# Arizona Nuclear Power Project

Subject: Final Report - DER 84-62  
A 50.55(e) Reportable Condition Relating To Load Sequencer  
Did Not Function Properly During Safeguards Testing.  
File: 84-019-026; D.4.33.2

FINAL REPORT - DER 84-62  
DEFICIENCY EVALUATION 50.55(e)  
ARIZONA PUBLIC SERVICE COMPANY (APS)  
PVNGS UNITS 1, 2, 3

Figure 1

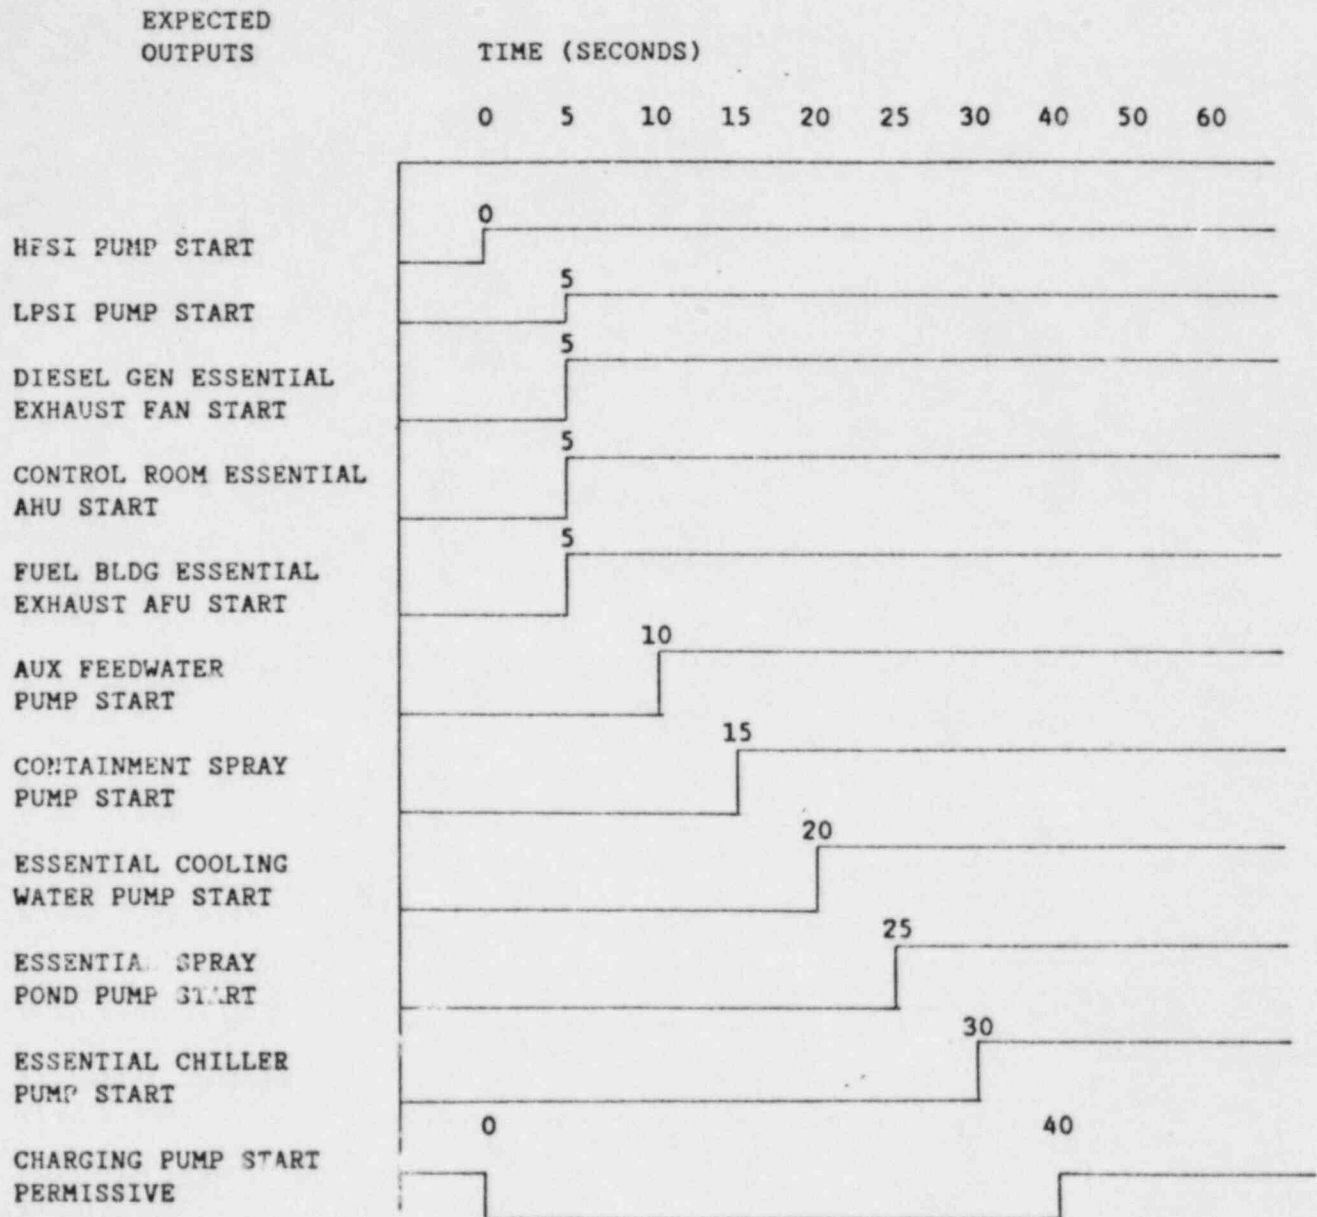
Mode 1 - Safety Injection Actuation Signal (SIAS) without Loss of Power (LOP). See Figure 1 for timing sequence.

In Mode 1, the Diesel Generator (D/G) is running with its breaker open and ready to close if off-site power is lost. Upon receipt of a LOP signal, the Diesel Generator breaker closes. This closure shifts the BOP ESFAS sequencer to Mode 2. The shift to Mode 2 causes the 480V Load Center (LC) main breakers and the High Pressure Safety Injection (HPSI) pump breaker to close 0.5 seconds later. However, the LOP event independently triggers a load shed signal of 1 second duration which keeps the LC and HPSI breakers open even though they receive a close signal 0.5 seconds after LOP occurs. These simultaneous "open" and "close" commands to the LC and HPSI breakers cause their anti-pump circuits to "lockout," thereby deenergizing the LC and preventing the HPSI pump from starting as required.

Figure 2A

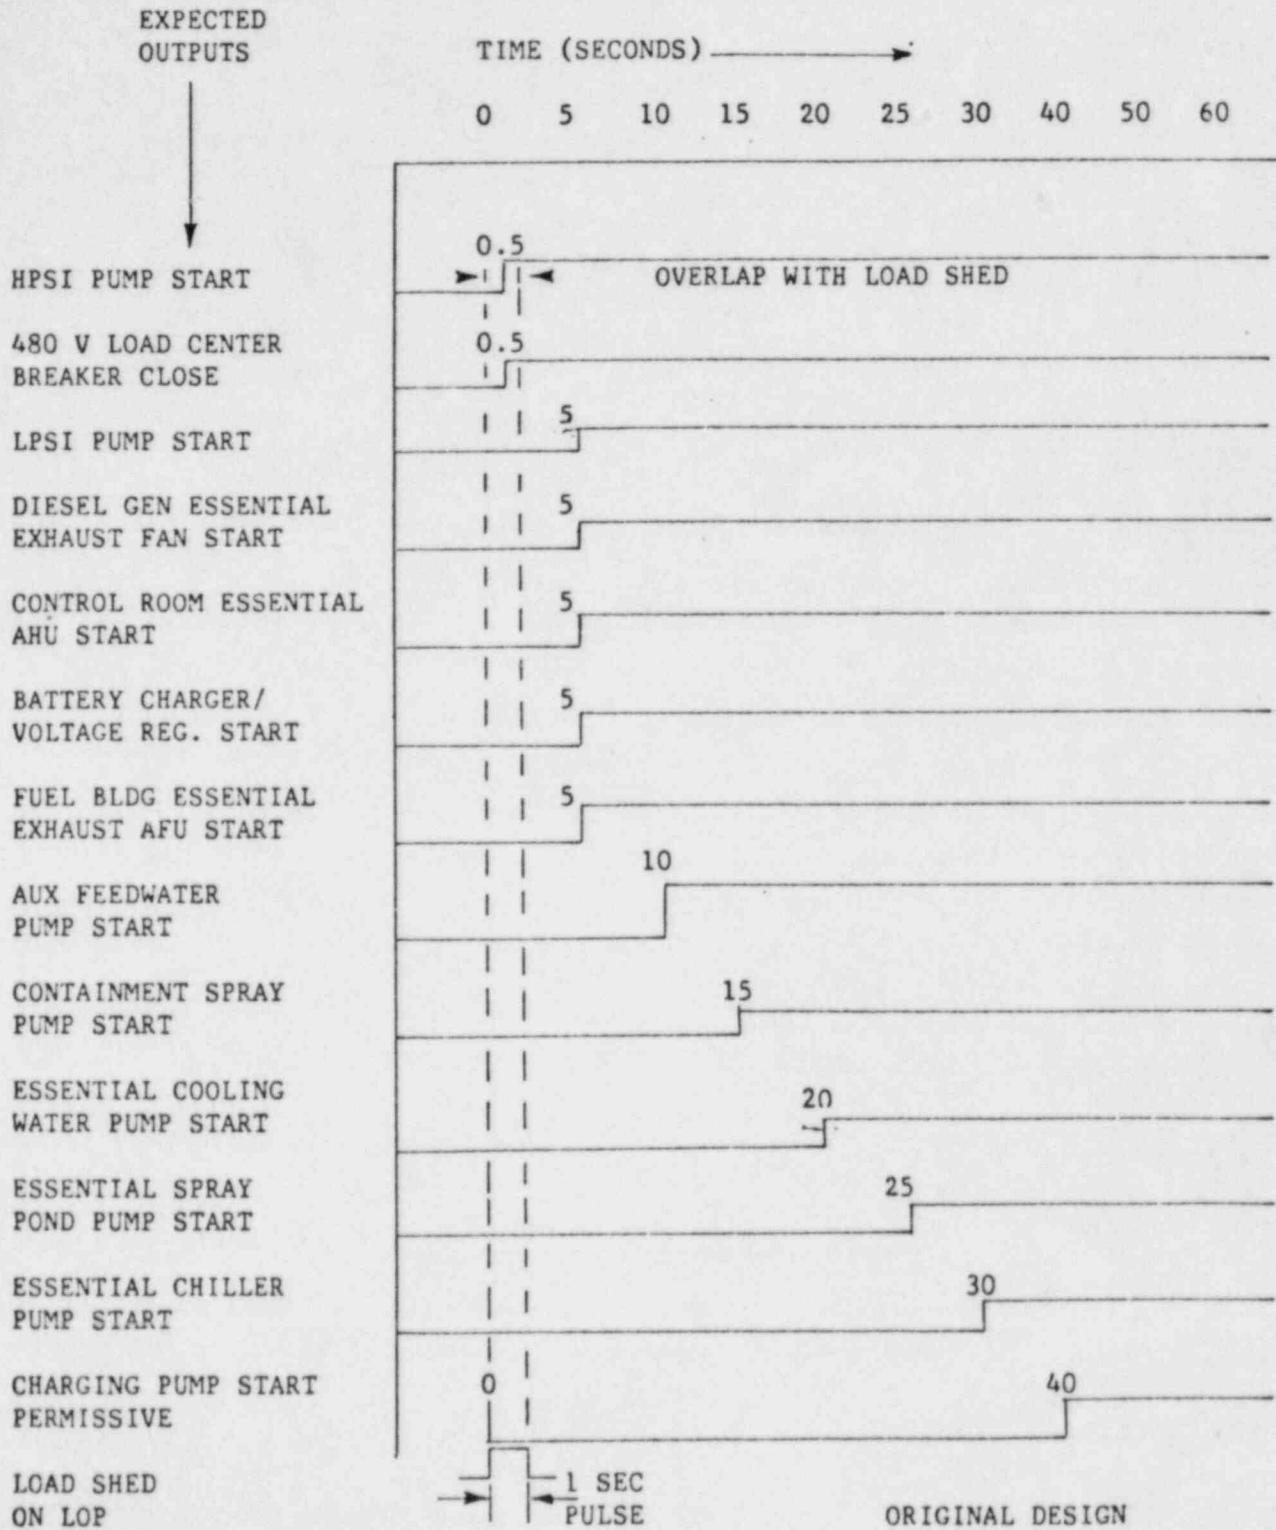
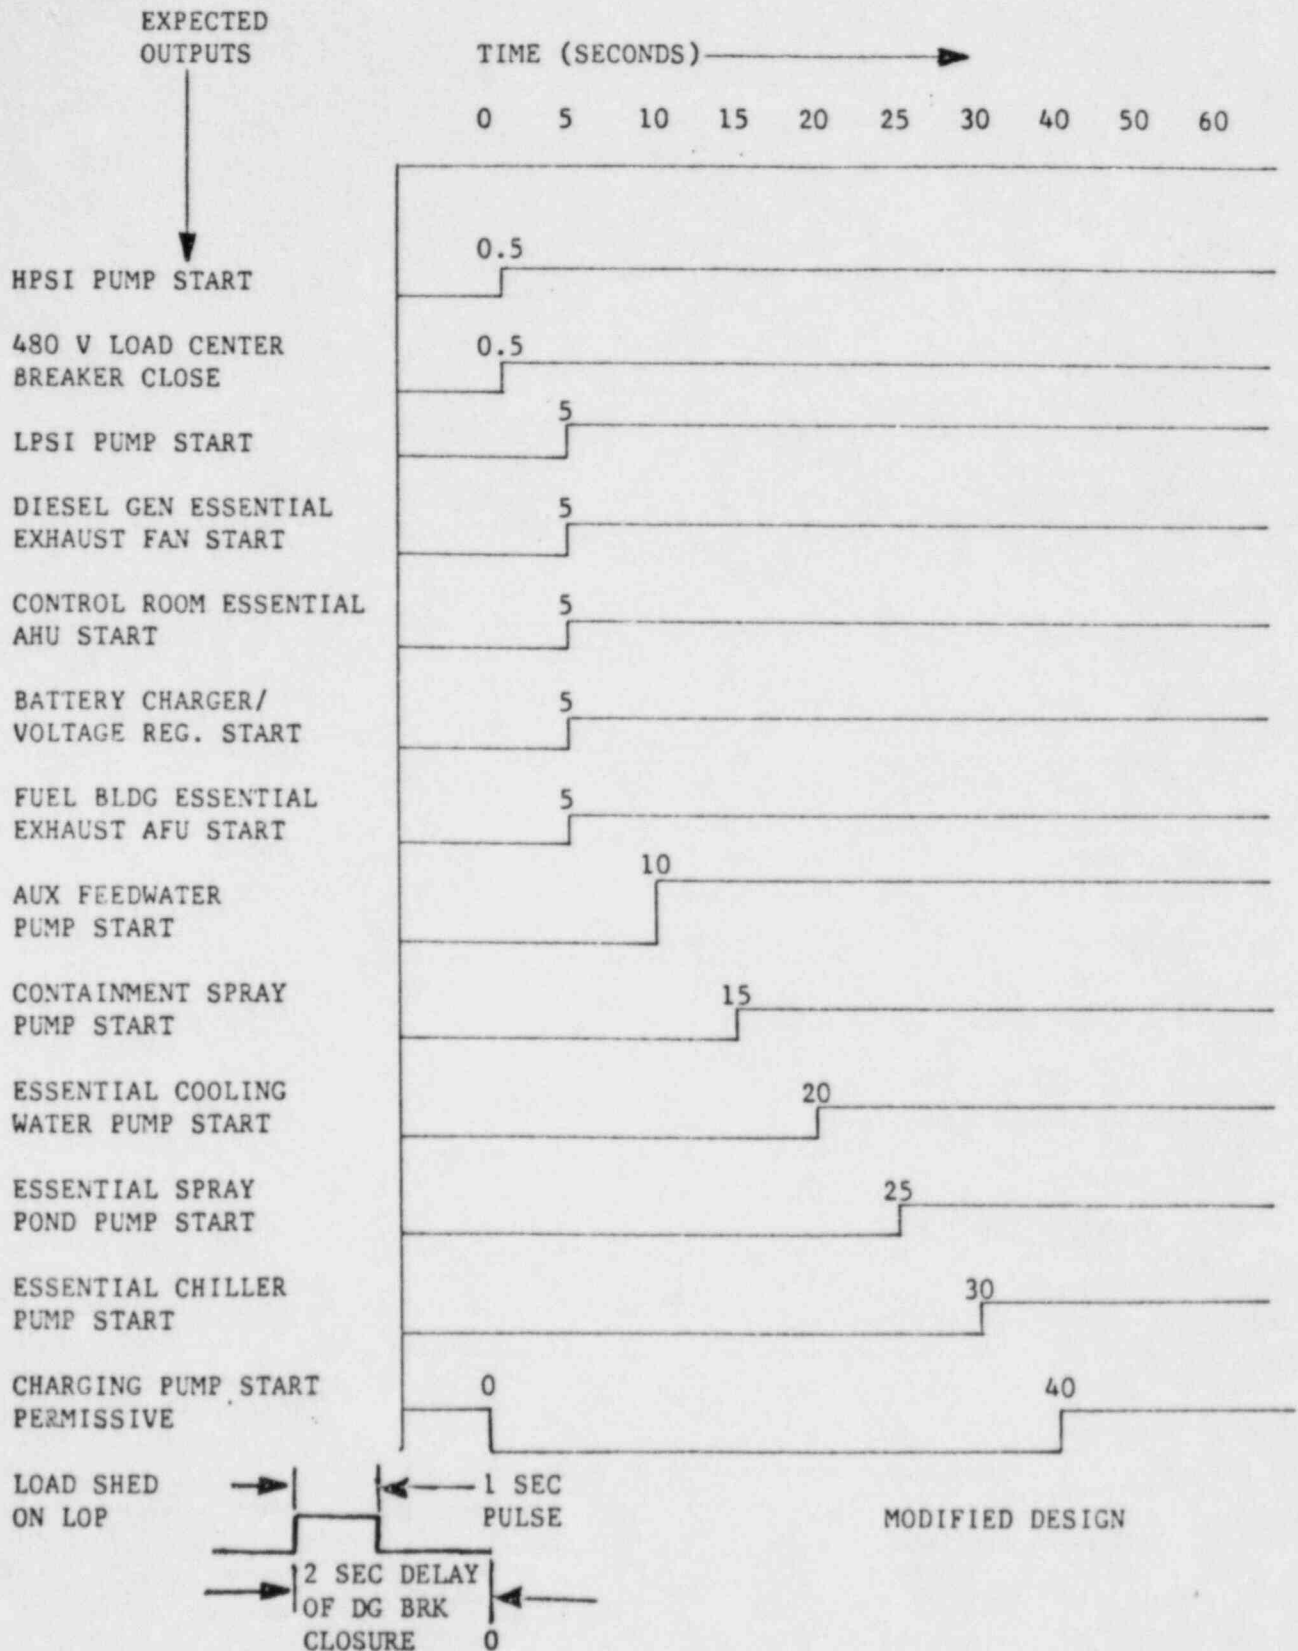
Mode 2 - SIAS with LOP. See Figure 2A for timing sequence.

Analysis of the recorder graphics taken during the pre-operational tests confirmed that the HPSI pump breaker did not close because it had locked into an anti-pump mode due to the presence of the simultaneous load shed (open) and start (close) signals.

In regards to the 480 volt center, the recorded data showed that its breaker did not close for the same reasons listed above; i.e., simultaneous open and close signals to its breaker which caused it to lock out. However, it was further noted that the breaker's closing spring charging motor requires a period of 2 to 5 seconds to re-charge after a trip (open circuit breaker) before it is capable of closing the breaker again.

The simultaneous "open" and "close" signals to the HPSI pump breaker were eliminated by delaying for 2 seconds the closing of the D.G. Breaker after a loss of offsite power following a SIAS. Since closing of the D.G. Breaker shifts the BOP ESFAS sequencer from Mode 1 to Mode 2, the entire sequence of contact closures for Mode 2 is also delayed by 2 seconds. Thus, since the LOP event independently triggers an immediate load shed signal of 1 second duration, the open and close signals are now totally separated by  $2 - 1 = 1$  second. This separation is schematically shown on Figure 2B. To accomplish this 2-second delay, two redundant Class 1E Agastat relays were connected in a "one-out-of-two" logic circuit which actuates the "close" circuit of the diesel generator circuit breaker. These relays are simultaneously energized on loss of offsite power and their respective contacts close in 2 seconds.

The problem regarding the simultaneous "start" and "stop" signal to the 480 volt load center breaker has been solved in the same manner as described above for the HPSI pump. Furthermore, the 2-5 second delay required by the 480 volt load center's breaker closing spring charging motor has been totally eliminated. This was accomplished by bypassing an interlock so that the breaker's closing spring will be recharged after the breaker is closed, instead of after it is opened, as it had been originally connected. Thus, the breaker will be ready to close immediately (without the 2-5 second delay) upon lifting of the load shed signal.

The simultaneous "open" and "close" signals to the HPSI pump breaker will be eliminated by adding an interlock to the HPSI pump circuit that does not allow the start signal from the BOP ESFAS sequencer to be applied to the HPSI pump breaker until after the load shed trip signal has disappeared/cleared.

The simultaneous "open" and "close" signals to the 480 volt load center breaker will be eliminated by deleting the load shed signal ("open" signal) after a loss of off-site power to this breaker. Thus the load center breaker will be continuously tied to the Engineered Safety Features (ESF) bus. It has been verified that this load will not degrade the operability of the diesel generator.
